Subject: TRIMMED: DA2025/0077 8 Undercliff Rd Freshwater Objection Submission

My family and I strongly object to the current development proposal at 28 Lawrence Steet Freshwater. This is primarily due to the obtrusive nature and scale of the design. This will significantly detract from the current communal feel of our beloved Freshy Village and reduce our quality of life as a Family.

Pic 1: Photo taken from the balconey at eye level looking directly north.

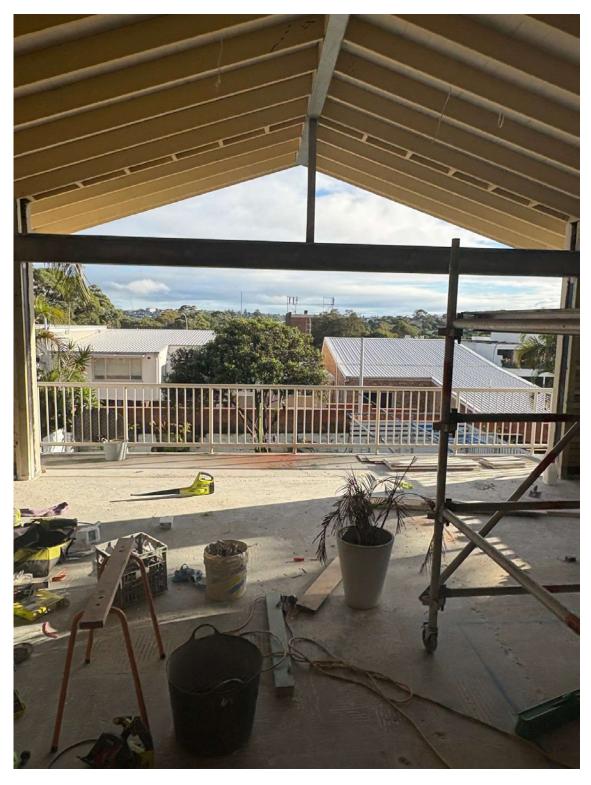
The visual impact study presented is inaccurate and misleading. All photos included within the report (specifically for 8 Undercliff) are outdated and do not represent the northerly direction which the new development will impact our house. We encourage the Planning Officer to attend our house and obtain an accurate, firsthand understanding of the visual impact the development will have on our family and adjoining neighbours. Below is a photo taken from the balcony on the mid floor where the main living and kitchen areas are located. This is presumably the location where figure 24 is taken within the report. It can easily be determined that the computergenerated image is inaccurate and minimises the current view loss, 'downplaying' the visual impact resulting from the development. The 1st floor living area will also have no district or sea views due to the enormity of the building causing significant loss of value to the property and enjoyment of use.

Tenacity step 3 states that the impact to 8 Undercliff will be 'moderate' this is inaccurate. It is clear to anyone visiting the property that the impact will be 'high-very high' due to loss of views, sunlight and privacy. This is clearly illustrated within the photos presented.
